TA03  
ENTERED  
NEW MEXICO  
ENVIRONMENT DEPARTMENT

*Hazardous Waste Bureau*

March 24, 2008

**RE: APPROVAL WITH MODIFICATIONS  
INVESTIGATION WORK PLAN FOR UPPER MORTANDAD CANYON  
AGGREGATE AREA  
LOS ALAMOS NATIONAL LABORATORY (LANL)  
EPA ID #NM0890010515  
HWB-LANL-07-040**

**Figure 3.18-2 Proposed sampling locations at SWMU 03-054(e) and AOC C-03-006**

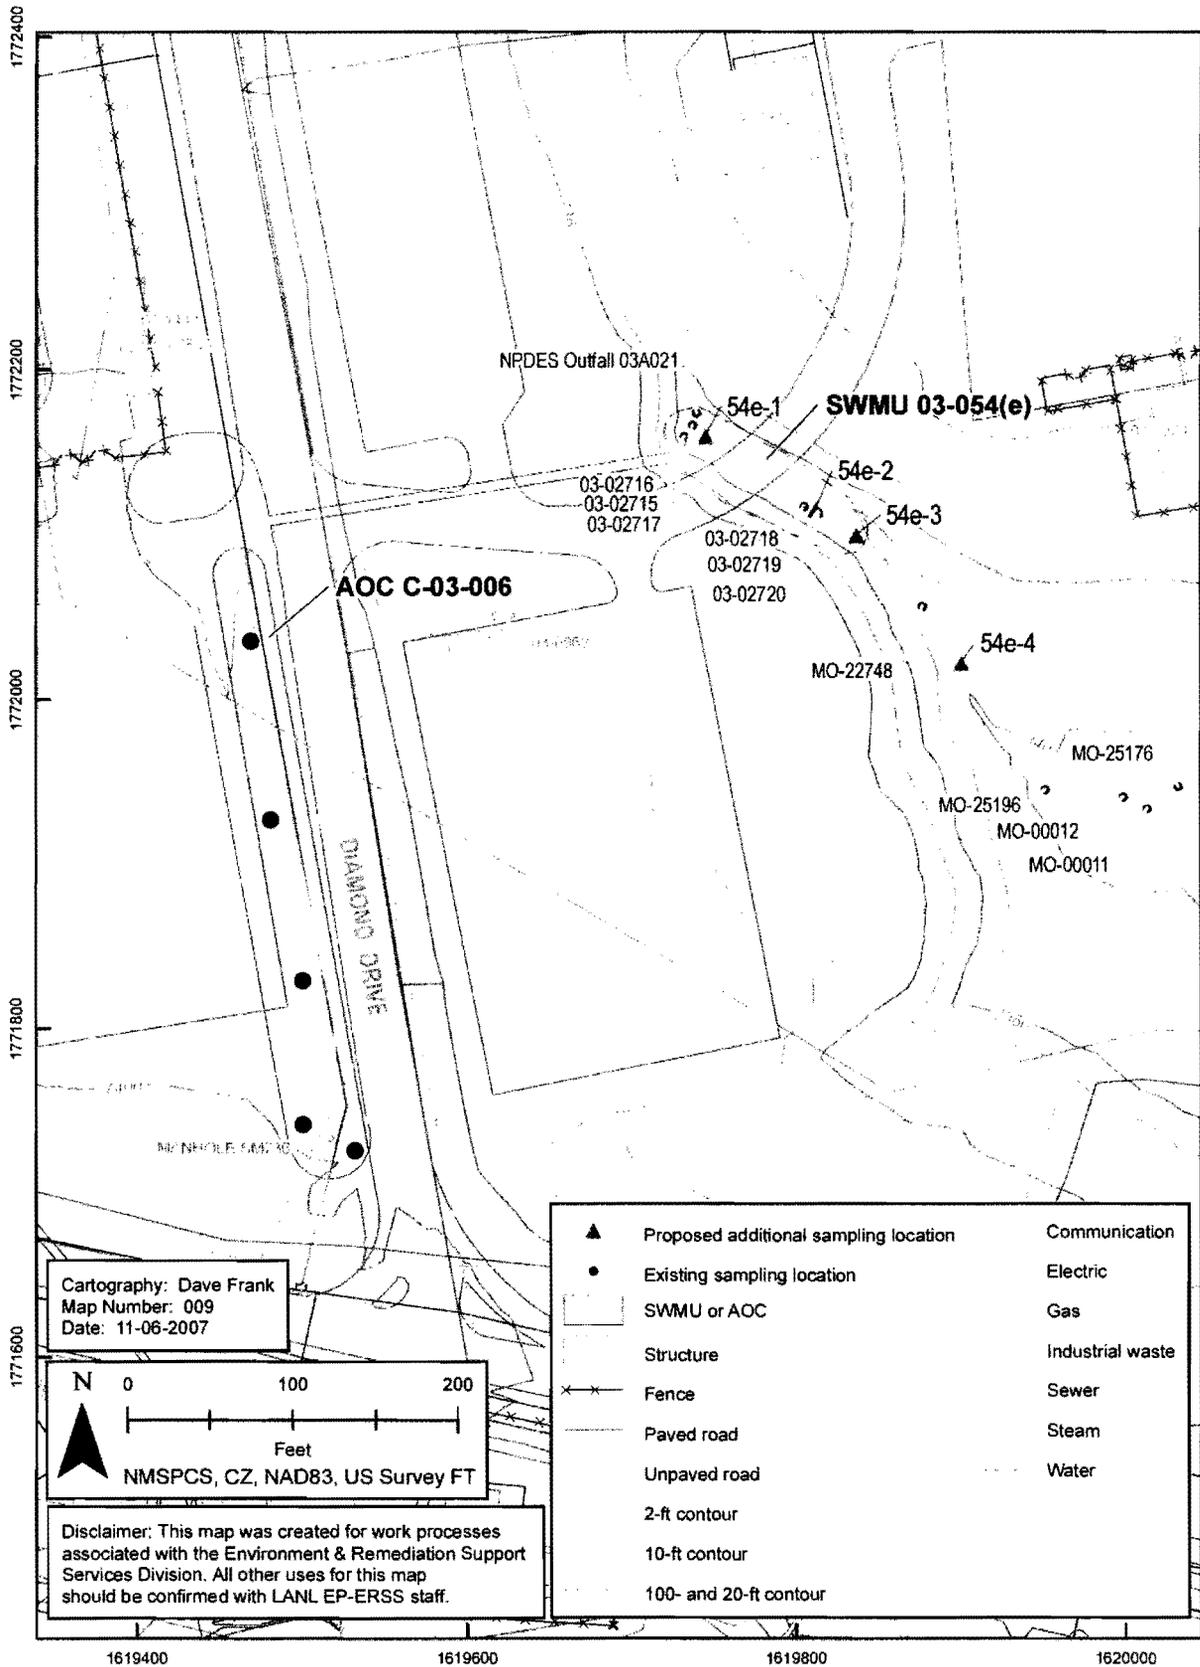
**33. NMED Comment:** The Permittees have proposed a seventh sample location at the outfall pipe. However, the Permittees did not change the associated text in Section 3.17.3. The Permittees must collect seven samples: four of the sampling locations near the 2001 sampling locations, two downslope of the previous and new locations, and one at the location of the outfall.

**Figure 3.15-1 Proposed sampling locations at SWMU 03-045(h) and SWMU 03-049(a) [Consolidated Unit 03-045(h)-00]**

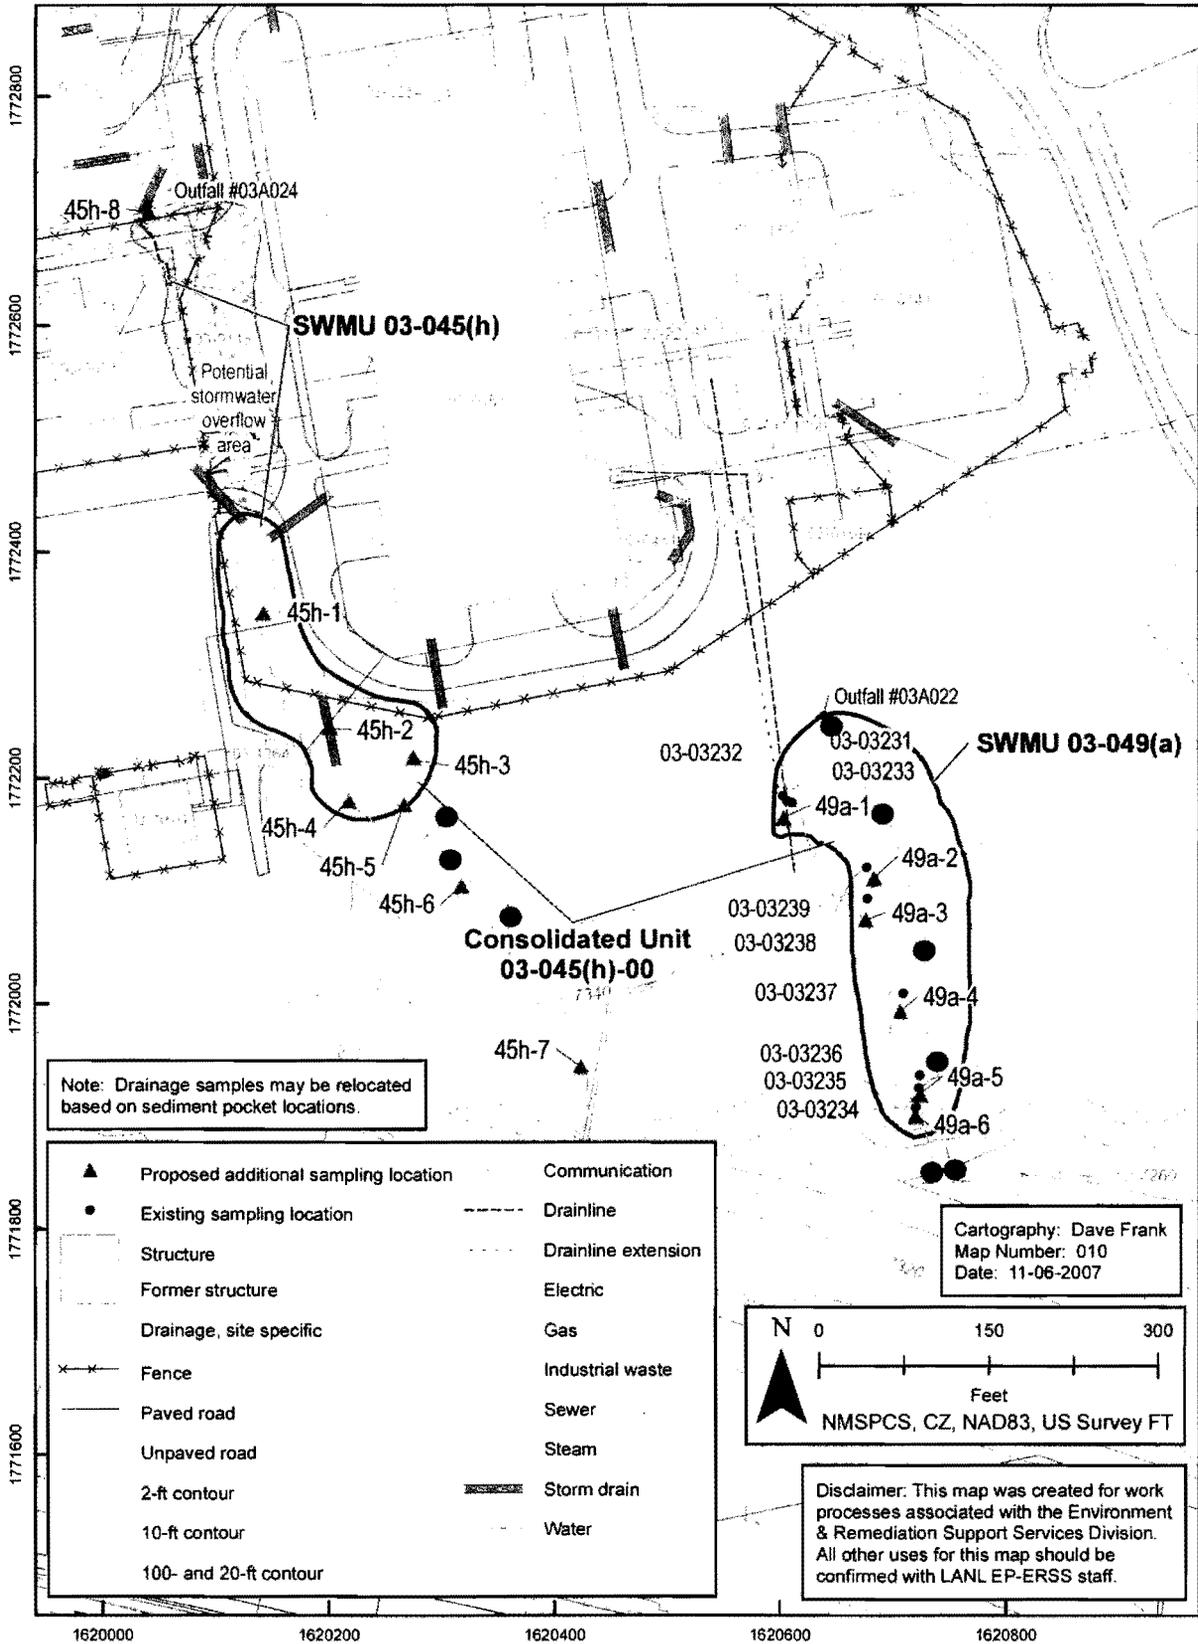
**26. NMED Comment:** The Permittees proposed sampling along only a portion of the entire length of the drainages at SWMU 03-045(h). The Permittees must collect samples at the additional locations identified on attached Figure 3.15-1. Samples must be collected at two depth intervals, consistent with the depths proposed in Section 3.15.3. Samples must be sent to an off-site fixed laboratory for the same analytical suite proposed in Table 3.15-5 for SWMU 03-045(h). The Permittees must include all sampling locations in all appropriate figures and tables in the Investigation Report.

**29. NMED Comment:** The Permittees proposed sampling locations in only some of the drainages depicted in Figure 3.15-1 for SWMU 03-039(a). The Permittees must collect samples at the additional locations identified on the attached Figure 3.15-1. Samples must be collected at two depth intervals, consistent with the intervals proposed in Section 3.15.3. All samples must be sent to an off-site fixed laboratory for the same analytical suite proposed in Table 3.15-5 for SWMU 03-049(a). The Permittees must include all sampling locations in all appropriate figures and tables in the Investigation Report.

Sample locations 49a-1, 49a-4, and 49a-5 are not depicted as being in the actual drainage; the Permittees must collect these samples from within the drainage at locations of sediment accumulation.

Figure 5.1-1 Site features for TA-48 SWMUs, AOCs, and consolidated units

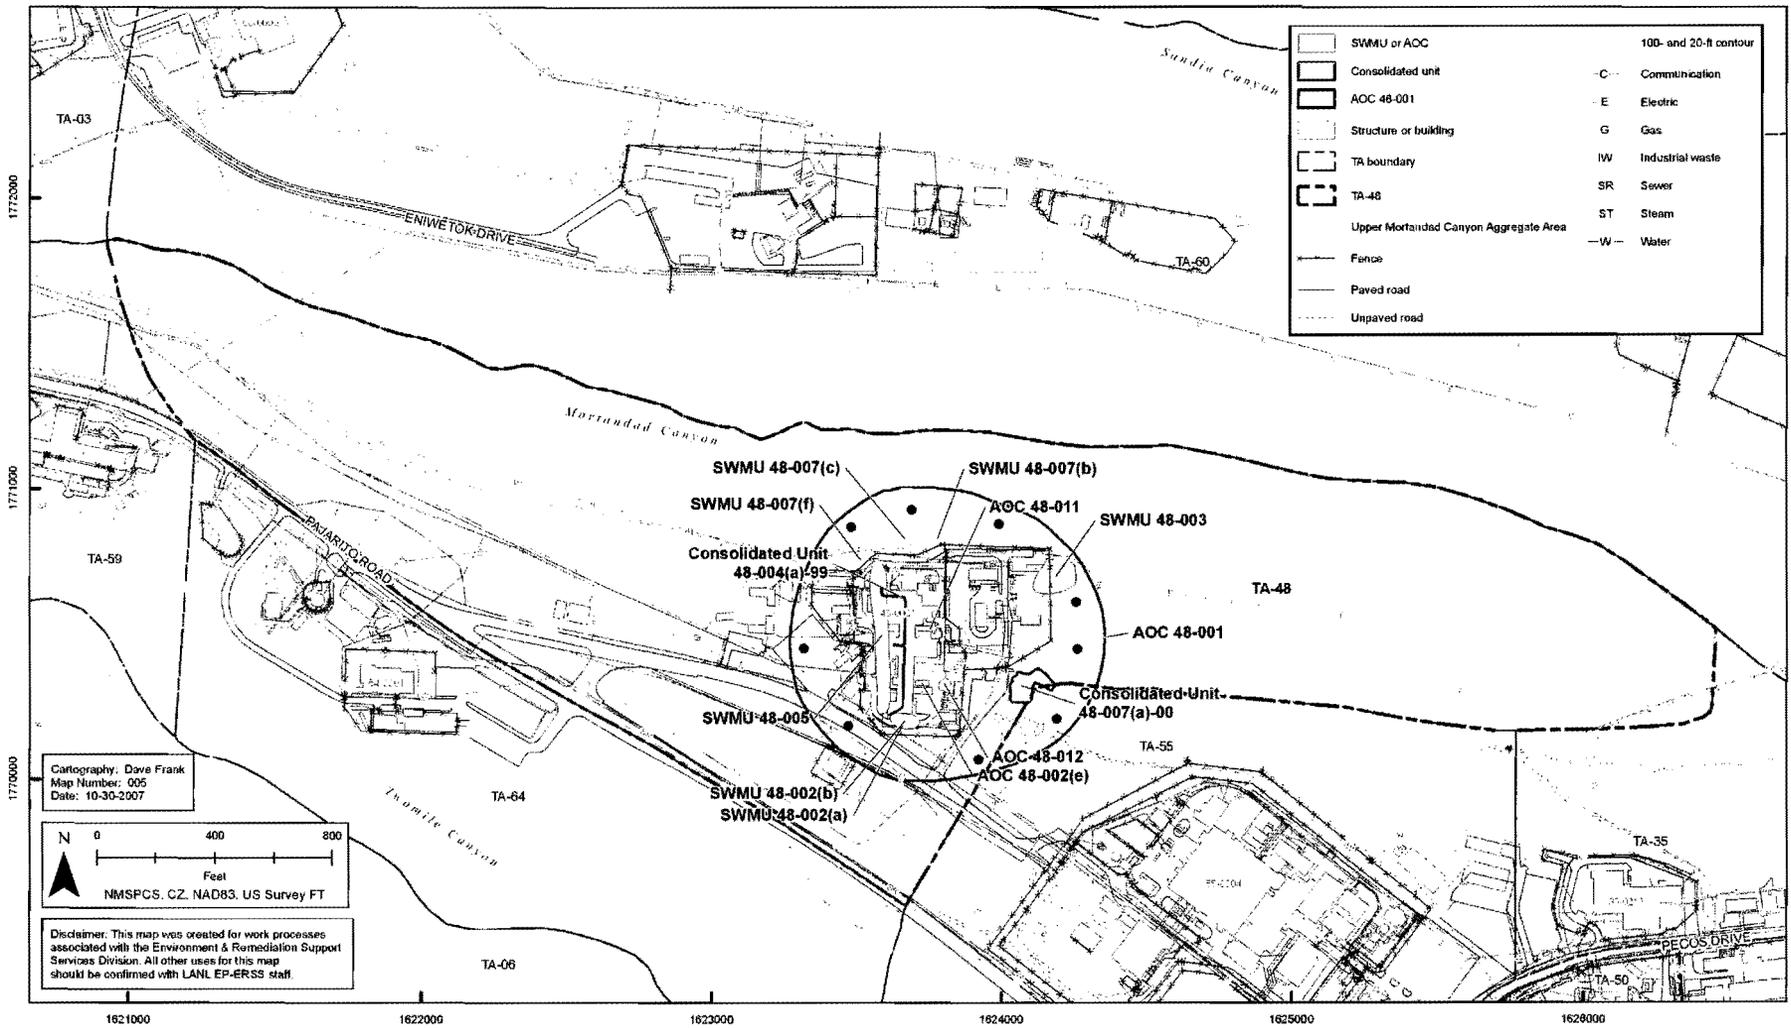
- 44. NMED Comment:** The Permittees state in their response that “Mortandad Canyon drainage samples will be used as applicable to determine whether the extent of contamination has been defined.” This does not address NMED’s comment. The Permittees did not propose to collect samples in the drainage, nor was the document that addressed the “Mortandad Canyon drainage samples” identified. The Permittees must collect samples every 50 feet from the top of the slope to the toe of the colluvium in the drainage associated with SWMU 48-007(a)-00. Two depth intervals must be collected at each location (0’-0.5’ and 1.0’-2.0’). Sampling must target areas such as fine-grained sediment in outfall channels or other areas of sediment accumulation. The samples must be analyzed for TAL metals, hexavalent chromium, tritium, SVOCs, VOCs (in samples deeper than 0.5 feet), perchlorate, nitrate, cyanide, pH, dioxins, furans, and gamma spectroscopy.

- 45. NMED Comment:** The Permittees must collect samples every 50 feet from the top of the slope to the toe of the colluvium in the drainage associated with SWMU 48-007(b). See specific comment # 44.

- 46. NMED Comment:** The Permittees must collect samples every 50 feet from the top of the slope to the toe of the colluvium in the drainage associated with SWMU 48-007(c). See specific comment # 44.

- 47. NMED Comment:** The Permittees must collect samples every 50 feet from the top of the slope to the toe of the colluvium in the drainage associated with SWMU 48-007(f). See specific comment # 44.

Figure 6.8-1 Proposed sampling locations at Consolidated Unit 50-004(a)-00

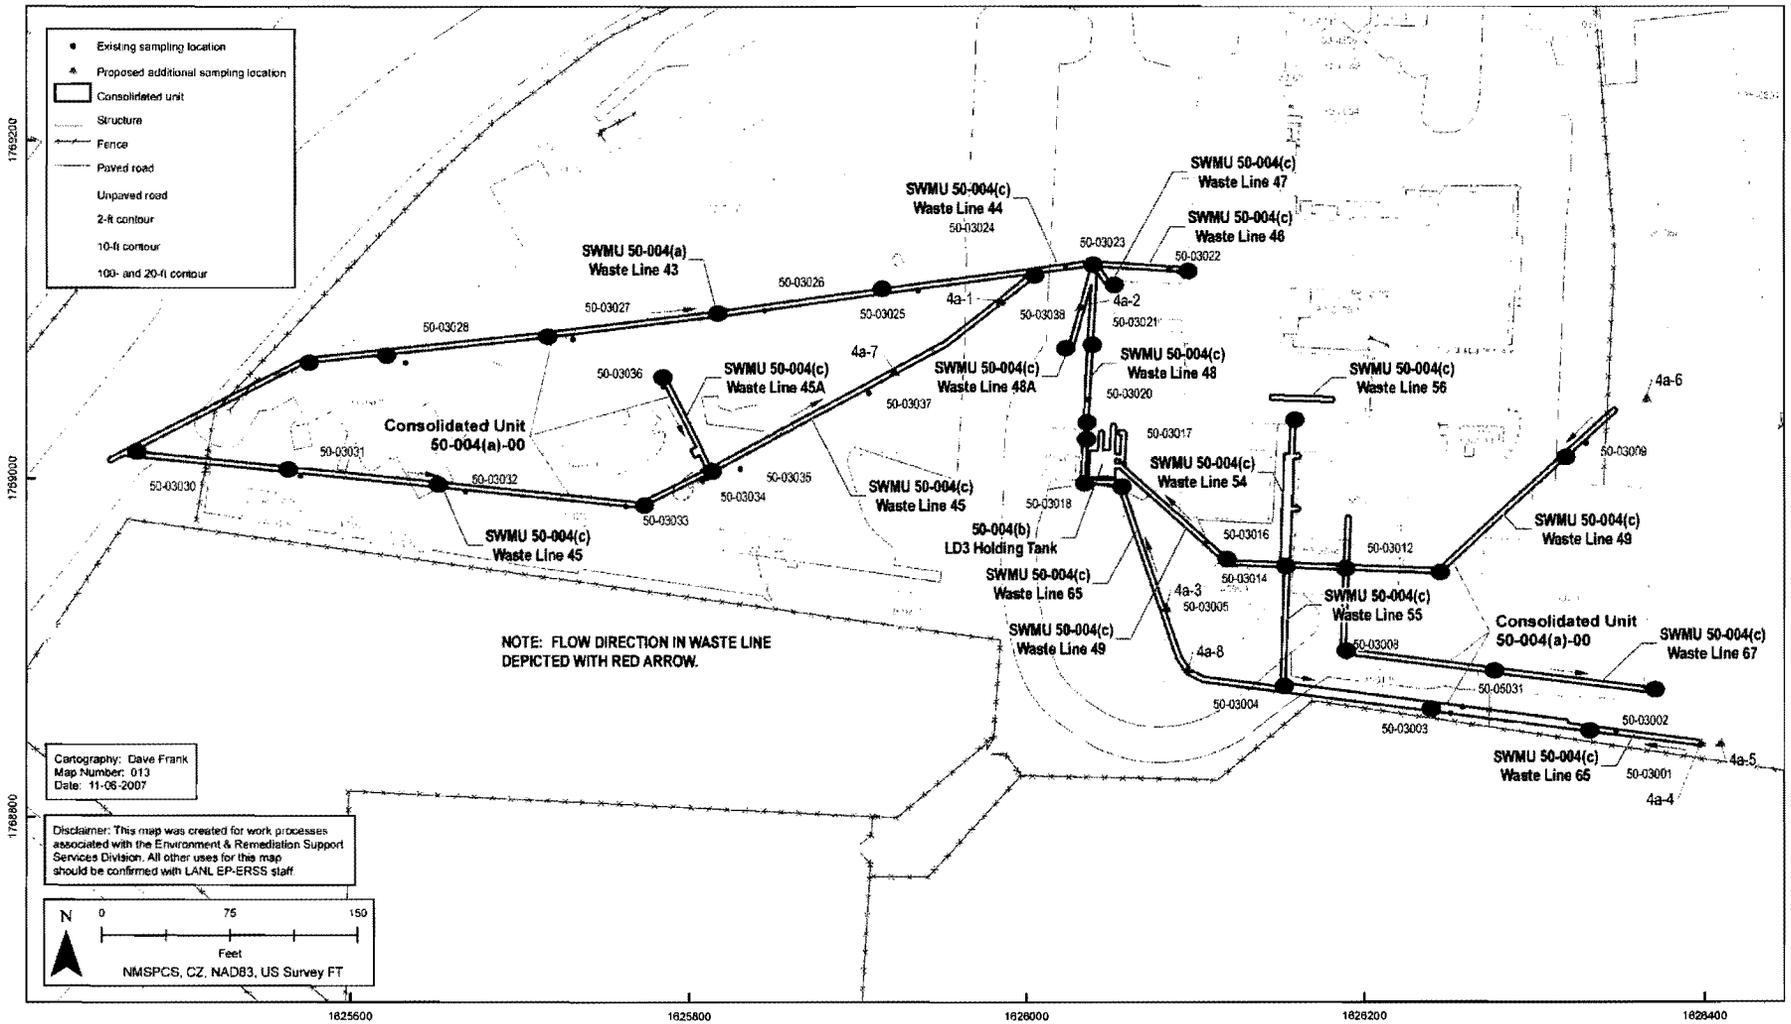
- 53. NMED Comment:** The Permittees did not address NMED's comment. The Permittees have proposed to collect eight samples (4a-1 – 4a-8) for Consolidated Unit (CU) 50-004(a)-00. According to Section 5.7 of the Historical Investigation Report (HIR) and Section 6.8 of the Plan, field screening was used to determine if 1994 regulatory levels had been achieved. Based on the above information, and because all waste lines have been decommissioned or removed (except line 56), the Permittees should have proposed sampling along all lines at CU 50-004(a)-00. The Permittees must collect samples at three depth intervals (corresponding to the base of the pipeline backfill, the soil/tuff directly below the backfill and at a depth five feet below the pipeline) from the 41 locations identified on the attached Figure 6.8-1. The samples must be analyzed for TAL metals, nitrate, perchlorate, gamma spectroscopy, isotopic plutonium, isotopic uranium, tritium, SVOCs, VOCs, cyanide, pH, PCBs, dioxins, and furans.

Figure 6.11-4 Proposed sampling locations at SWMU 50-006(d)

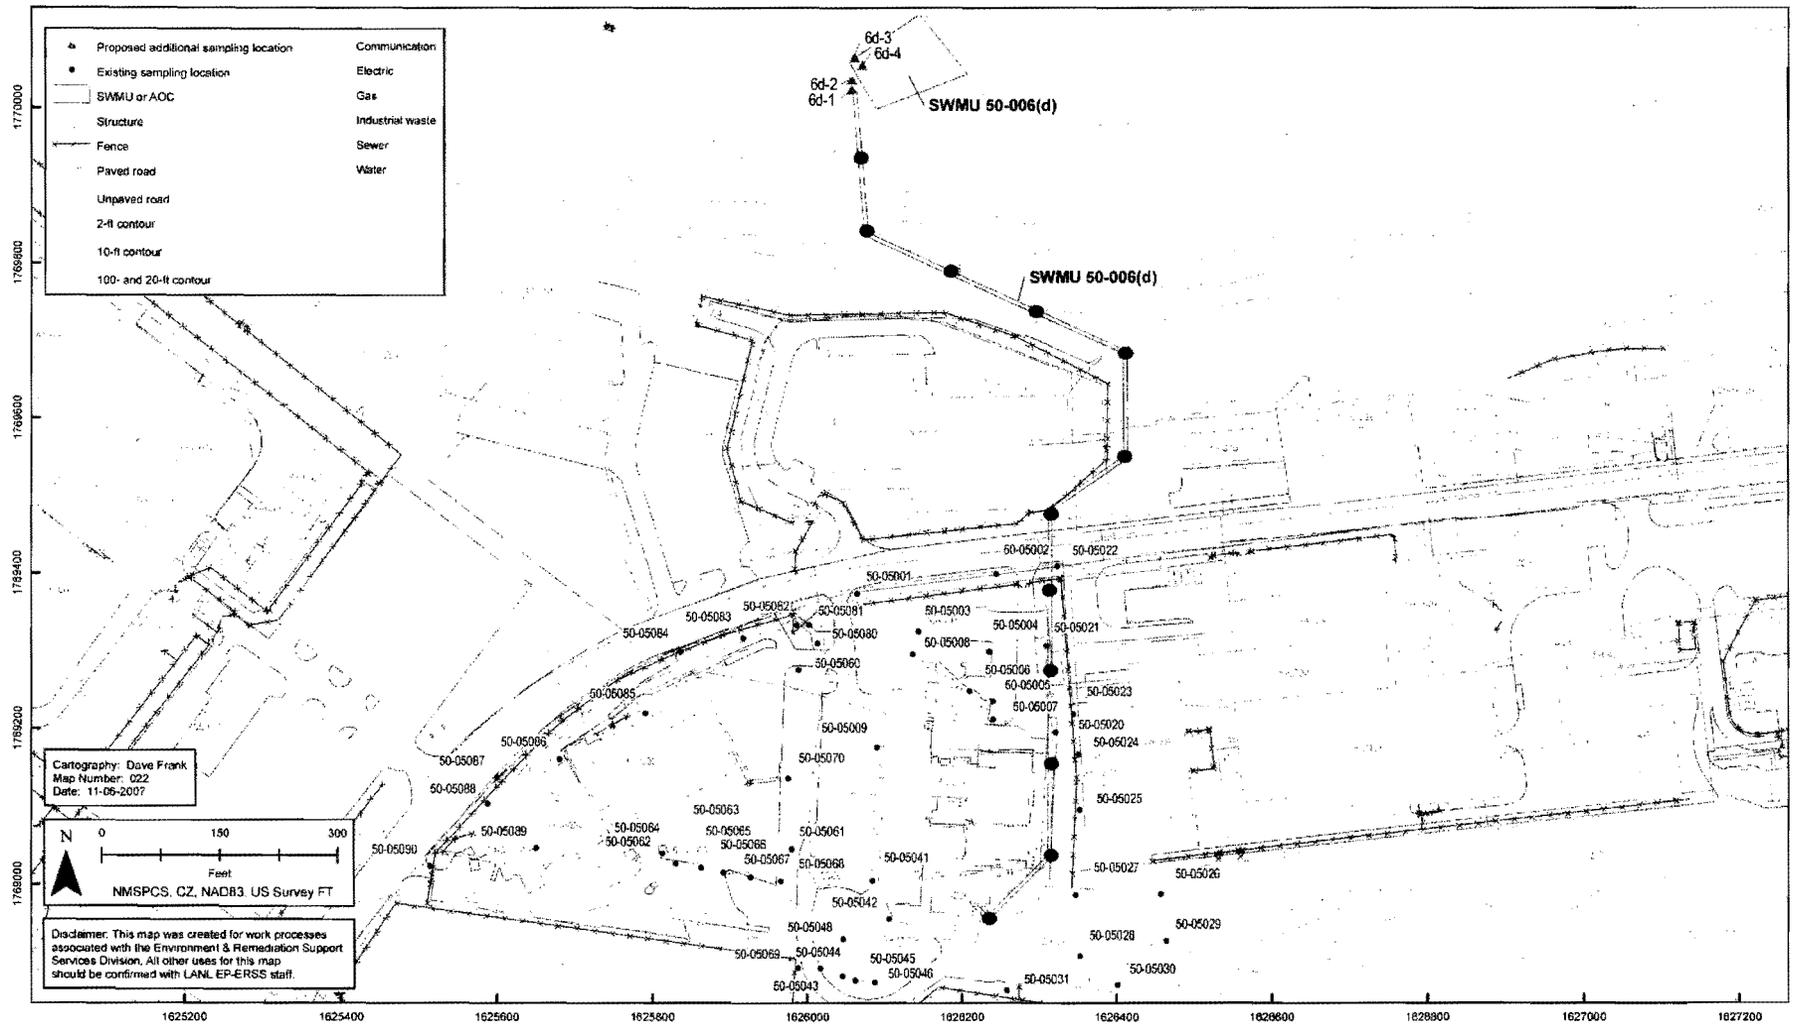
- 58. NMED Comment:** Section 6.11 of the Plan states that SWMU 50-006(d) consists of a drainline and associated NPDES-permitted outfall. The Permittees did not propose any samples beneath the drainline which runs from Building 50-0002 to the outfall. The Permittees must collect samples at the locations shown on attached Figure 6.11-4. Two depth intervals must be sampled at each location (one directly beneath the line and the

other five feet below the base of the line). Samples must be analyzed for the same analytical suite as that proposed for the four outfall samples.

The Permittees state in their response that “[r]esults from samples collected within the main Mortandad Canyon drainage during other investigations will be used, as applicable, to determine whether the extent of contamination has been defined for SWMU 50-006(d).” This does not address NMED’s comment. The Permittees did not propose drainage samples, nor did they identify which document addressed the “Mortandad Canyon drainage samples”. The Permittees must collect samples every 50 feet from the top of the slope to the toe of the colluvium in the drainage(s) associated with SWMU 50-006(d). Two depth intervals must be collected at each location (0-0.5 and 1.0-2.0, feet below ground surface (bgs), respectively). The sampling must target areas of sediment accumulation such as fine-grained sediment in outfall channels. The samples must be analyzed for the same analytical suite as that proposed for the four outfall samples.
